United Nuclear - Mallinckrodt

70-36  
S-8

Feb. 27, 1962

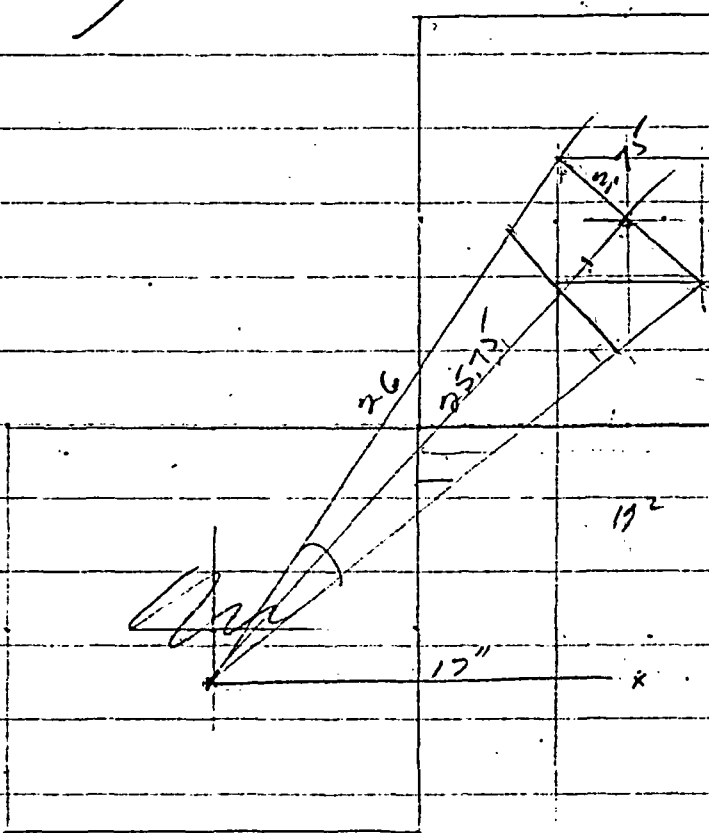
Value somewhat high  
because ruffen container  
initially

.067  
+ 12 drums in 14  
direction  
also below

Value in .7+  
because they assumed  
spheres.
